Walkable Midtown: The Midtown-St. Albans Area Plan

Planning Commission
Committee of the Whole
Sept. 24, 2020

Comments from August COW

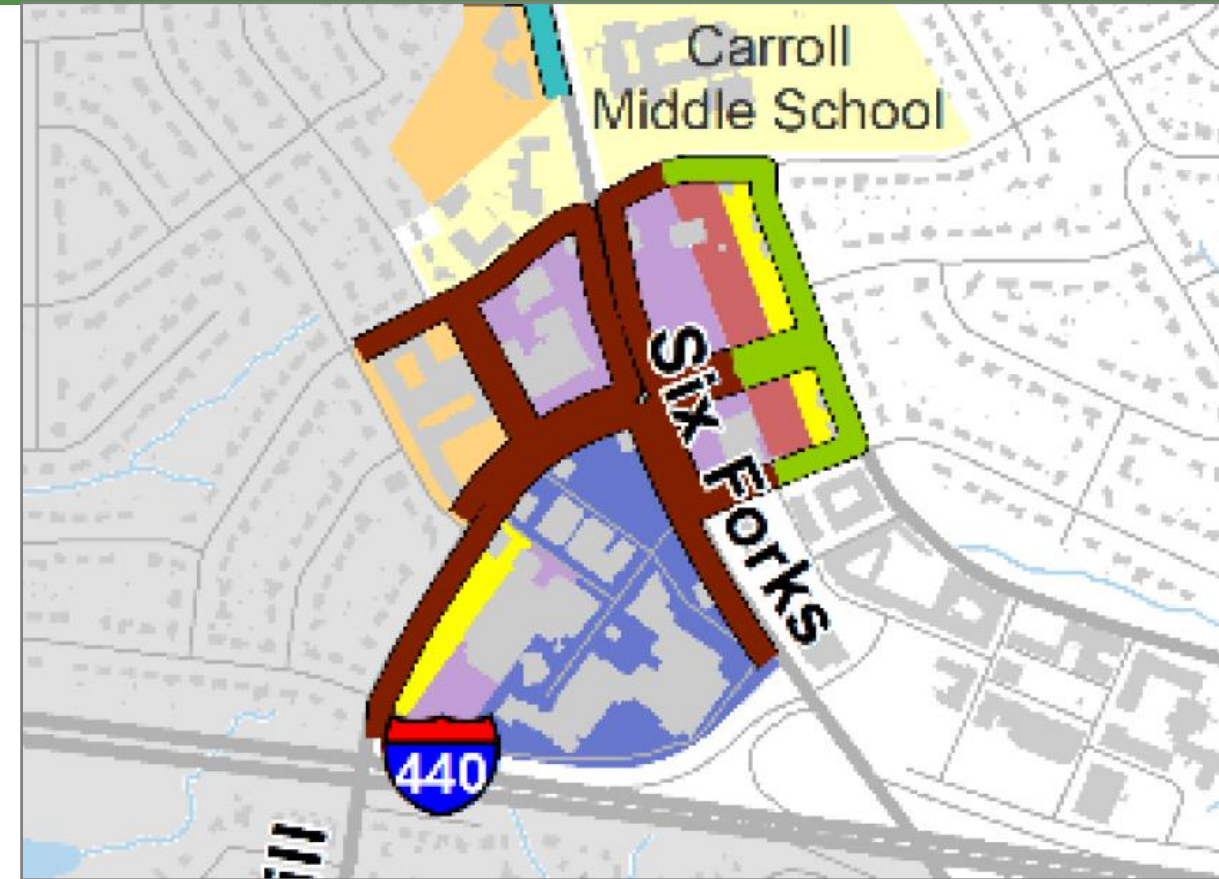
Comment: Six Forks should not have an urban frontage

Plan principle: Create more walkable places, include building entrances on street

Feedback: Little specific input, but reflects a primary input theme

Options:

1. Retain Plan recommendation
2. Revise to recommend a less urban frontage

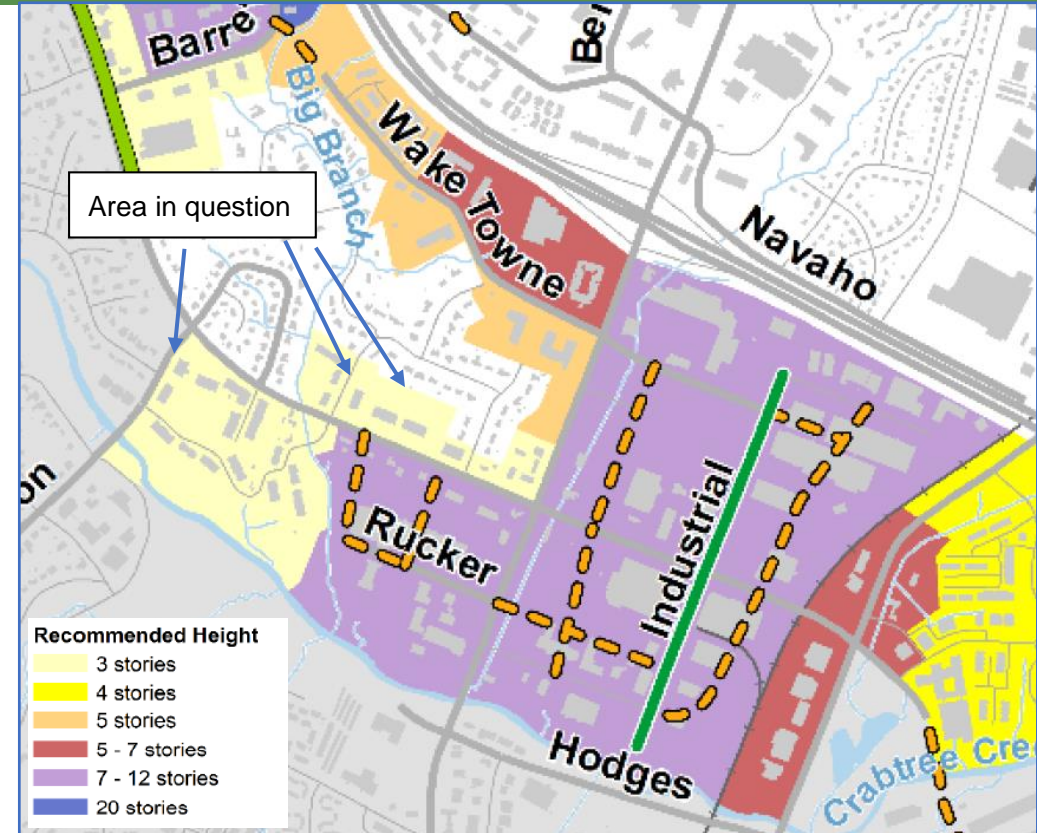
Comment: At least four stories should be allowed on Hobbs/nearby properties on Six Forks. Plan recommends three. Current zoning is three stories; current height guidance is 4/5 on north, 4 on south

Plan principle: Transition from taller mixed use area east and south

Feedback: Survey illustrated transitions from 12 stories at core of the Waterfront area to three stories on the edges. 75 percent favorable

Options:

1. Retain Plan recommendation
2. Revise to reflect general guidance of four/five stories

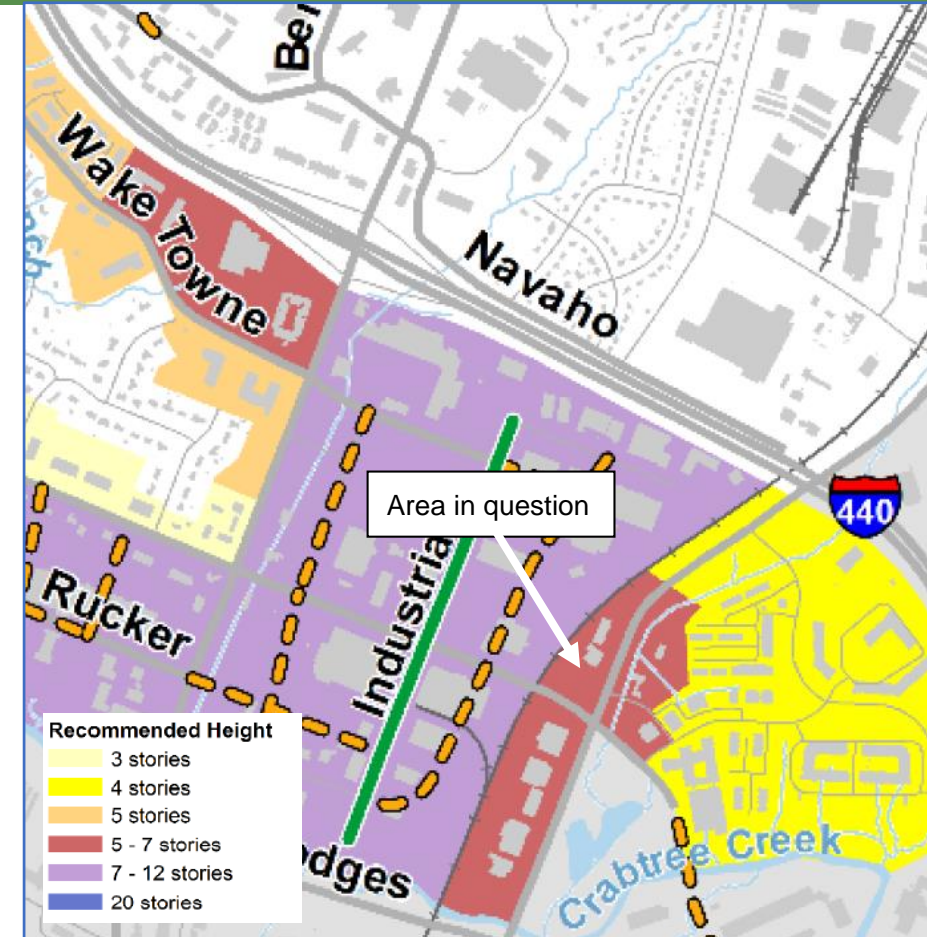
Comment: At least four stories should be allowed on Hobbs/nearby properties on Atlantic. Plan recommends 5-7. Current zoning is three stories; current general height guidance is five stories.

Plan principle: Allow more housing/employment in a walkable center

Feedback: Survey illustrated transitions from 12 stories at core of the Waterfront area to three stories on the edges. 75 percent favorable.

Options:

1. Retain Plan recommendation
2. Revise recommendation. Additional height beyond that explored by the plan process ideally should involve a new process

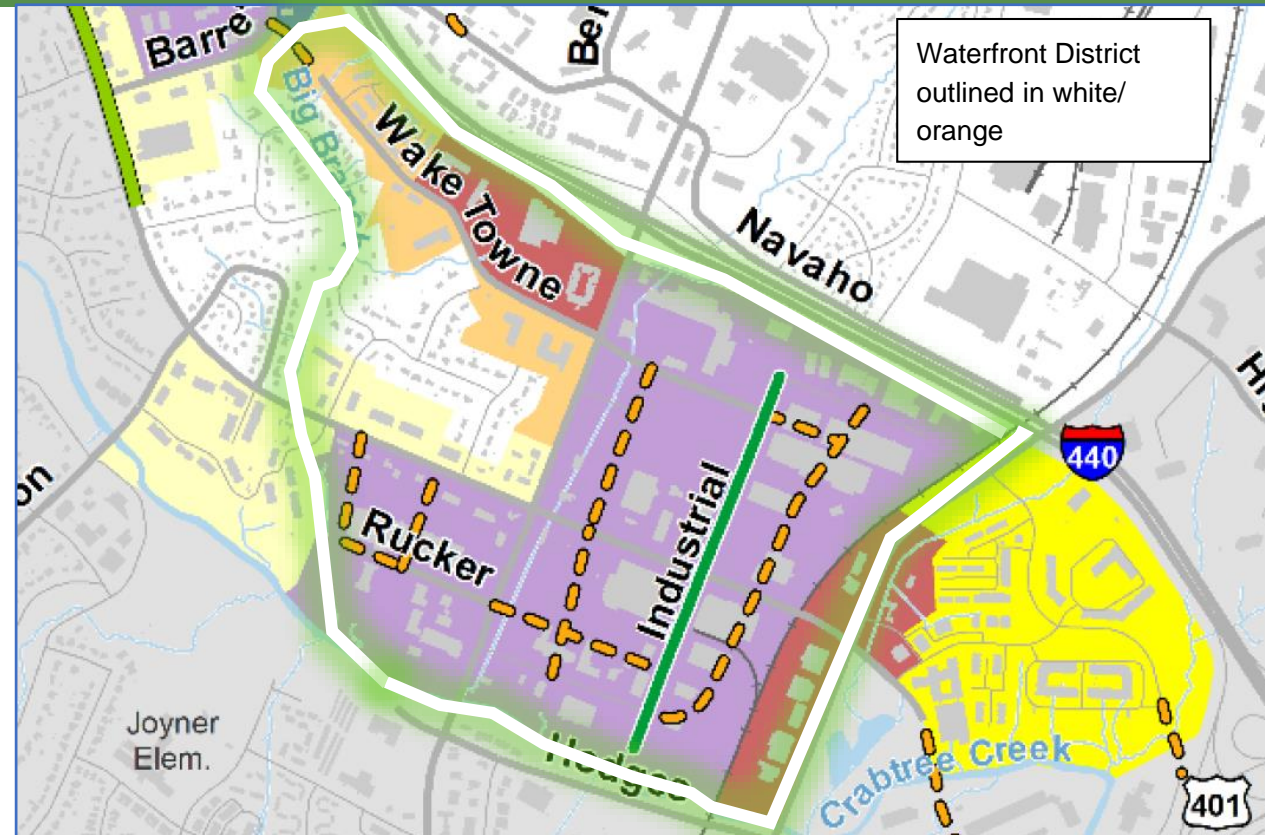
Comment: Parking should be allowed between the building and street in the Waterfront District

Plan principle: Allow more housing/employment in a walkable center

Feedback: Not specifically asked, but a key part of the core concept of a walkable waterfront/Main Street concept (82 percent positive, 136 responses to this question) and overall input

Options:

1. Retain Plan recommendation of no parking between building and street
2. Revise recommendation to allow some parking (hybrid frontage)

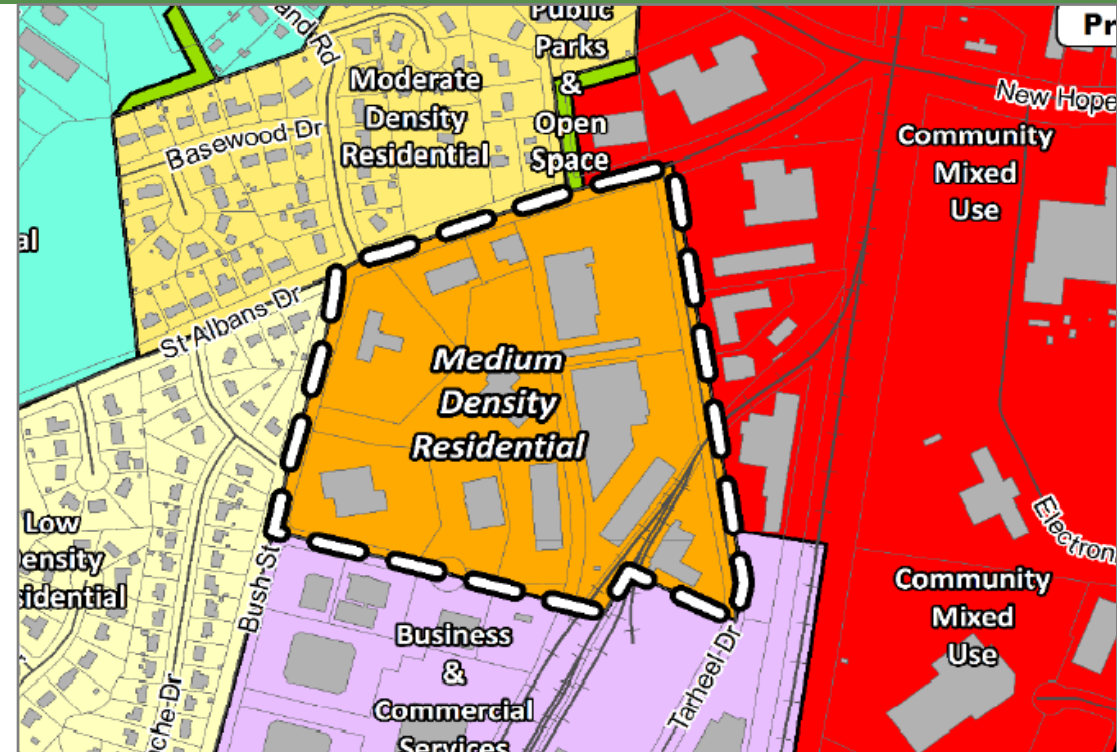
Comment: FLUM for St. Albans/Bush area should support office/other commercial uses

Comment: More height (12 stories) should be allowed in the St. Albans/Bush area. Plan recommends 4/5.

Plan principle: Allow more housing opportunities and create a transition to residential area to north

Feedback: 69 percent favorability as a way to accommodate more housing choice (120 respondents)

Options:

1. Retain Plan recommendation of Medium Density Residential
2. Revise recommendation to a category that better facilitates housing while also supporting office and retail uses. Office and Residential Mixed Use or Neighborhood Mixed Use
3. Revise recommendation to retain adopted Business and Commercial Services

Plan principle: Avoiding stark transitions to lower-scale areas

Feedback: Not asked separately from FLUM change; 69 percent favorability as a way to accommodate more housing choice (120 respondents)

Options:

1. Retain Plan recommendation of 4/5 stories
2. Revise recommendation to retain existing height guidance of three stories
3. Revise to allow additional height. Additional height beyond that explored by the plan process or current height guidance ideally should involve a new process.

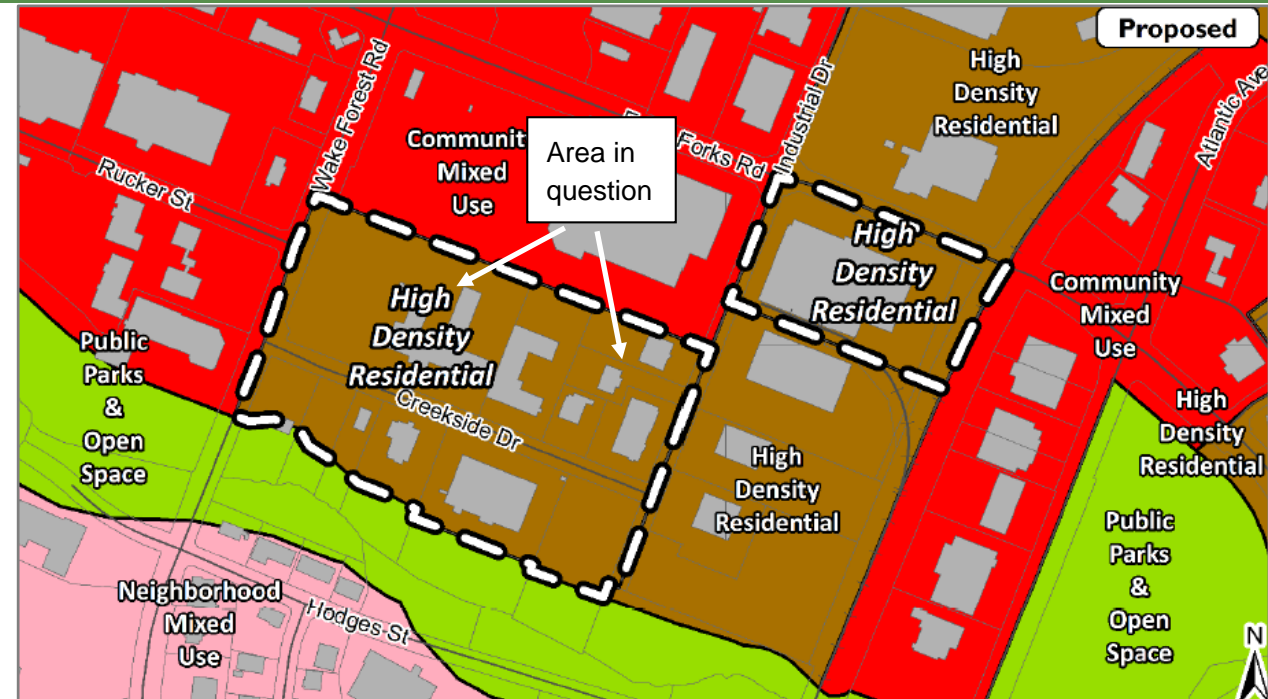
Comment: Leave Thompson properties (car dealership) as Community Mixed Use on FLUM. Plan recommends High Density Residential

Plan principle: A more lively Waterfront District by adding residential uses, encouraging a balance between commercial/residential uses.

Feedback: 77 percent average support (125 respondents)

Options:

1. Retain Plan recommendation of High Density Residential
2. Revise recommendation to designate as a category that avoids higher impact commercial uses but still allows a mix of housing, office, and retail, such as Neighborhood Mixed Use or Office and Residential Mixed Use.
3. Revise recommendation to retain existing Community Mixed Use designation.

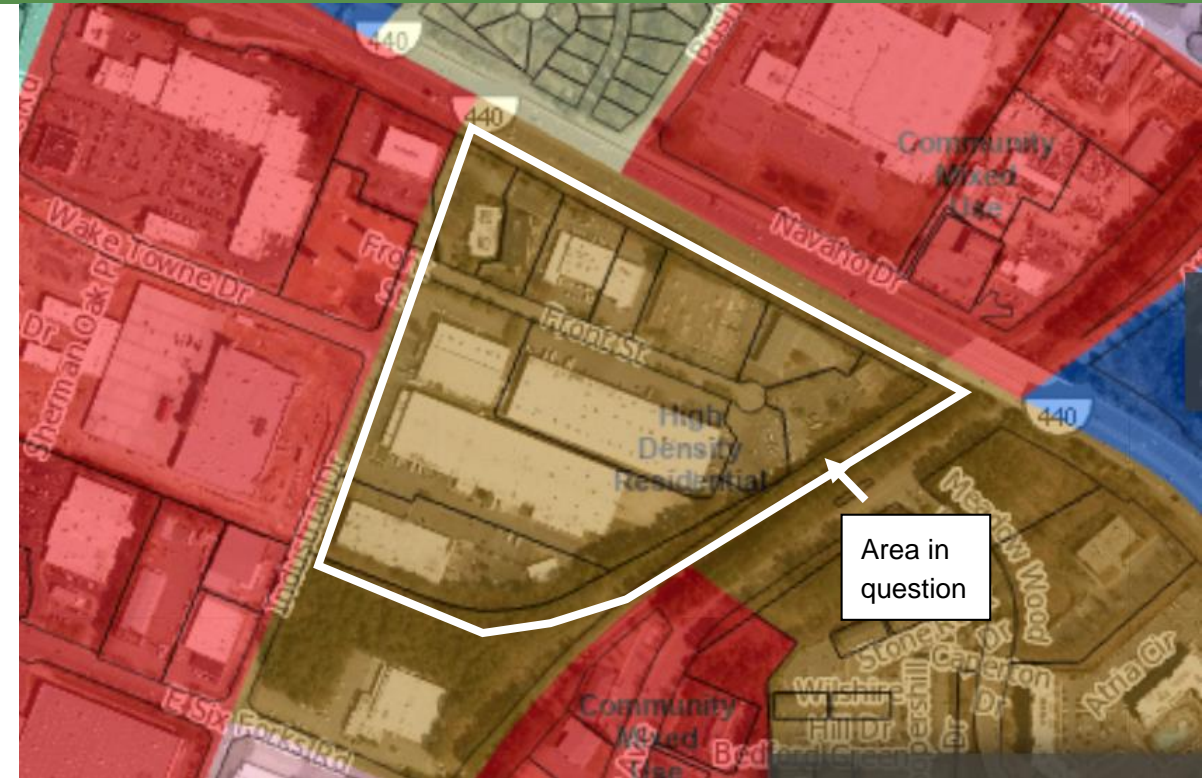
Comment: Commercial Mixed Use is an appropriate designation for Industrial/Front street properties

Plan principle: The plan does not propose a change from HDR, which envisions commercial uses on ground floor. The plan does amend that guidance by supporting office uses in the district

Feedback: Land use vision for Waterfront District received 77 percent favorability (125 respondents)

Options:

1. Retain current designation of High Density Residential
2. Create a recommendation to revise to a category that avoids higher impact commercial uses but still allows a mix of housing, office, and retail, such as Neighborhood Mixed Use or Office and Residential Mixed Use.
3. Revise to Community Mixed Use designation, which does reflect existing zoning.

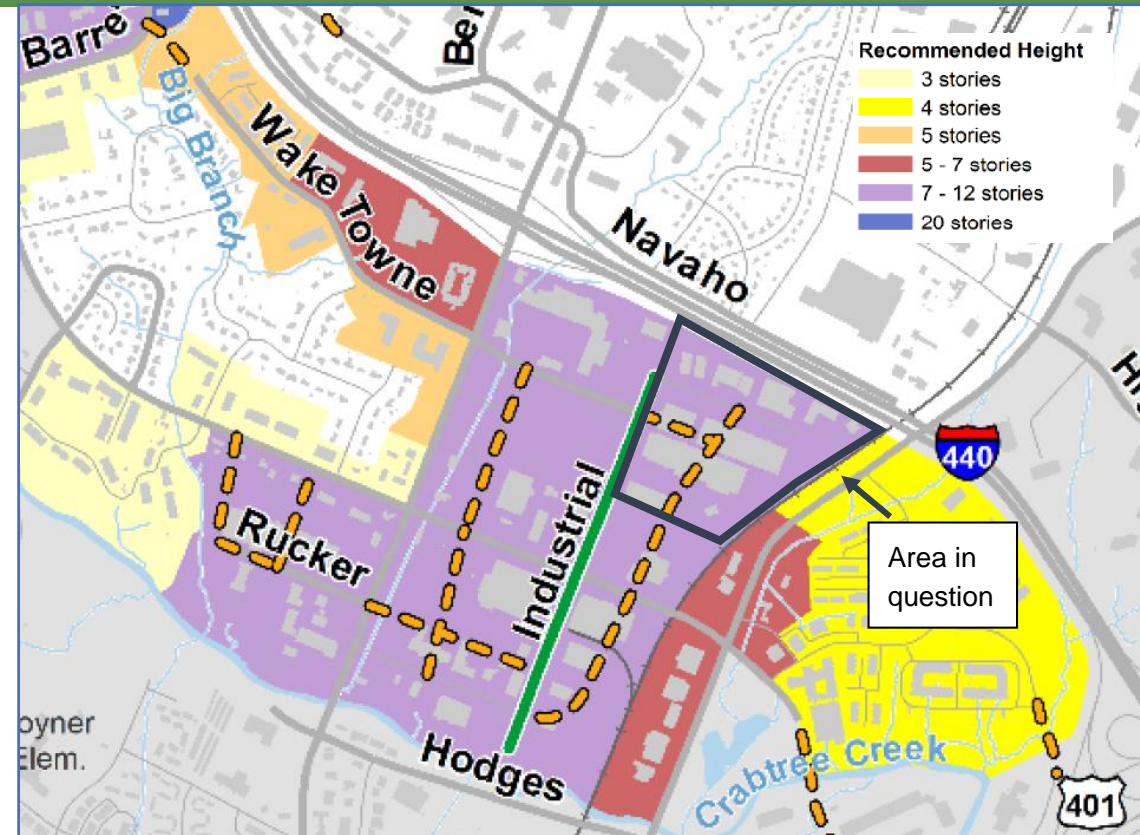
Comment: More height (20 stories) should be allowed in Industrial/Front area. Plan recommends up to 12.

Plan principle: The plan's tallest recommended heights of 20 stories are at/near the core of the Midtown area, with tallest existing buildings and highest levels of planned frequent transit

Feedback: Survey asked about transitions from 12 stories at core of the Waterfront to three stories on edges. 75 percent favorable average. (115 responses)

Options:

1. Retain Plan recommendation of 12 stories (existing general height guidance in either the High Density Residential or Community Mixed Use categories also is up to 12 stories)
2. Additional height beyond that explored by the plan process or current height guidance ideally should involve a new process. Any property owner or resident may request a FLUM change.

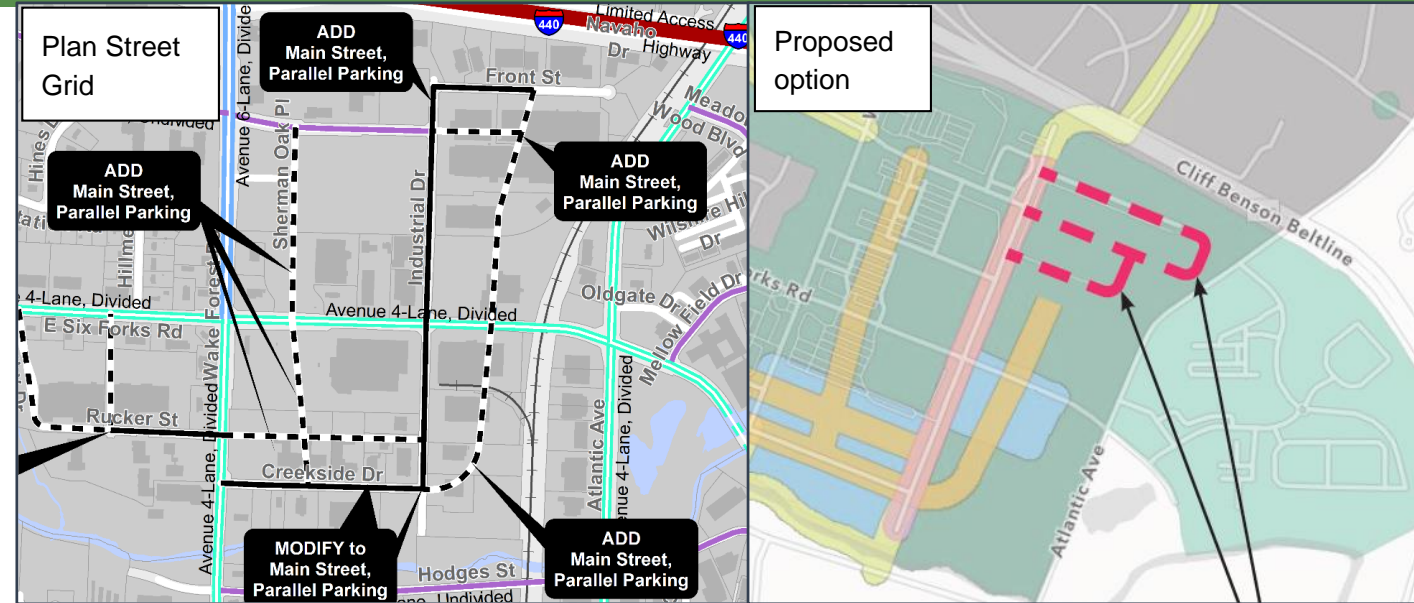
Comment: Amend street plan recommendation at Industrial/Front

Plan principle: A connected grid is essential for walkability

Feedback: Not asked specifically, but a desire for walkability was a core input theme

Options:

1. Retain existing proposal for Street Plan
2. Recommend alternate proposal, with provision that it connects to Creekside Drive extension
3. Recommend alternate proposal
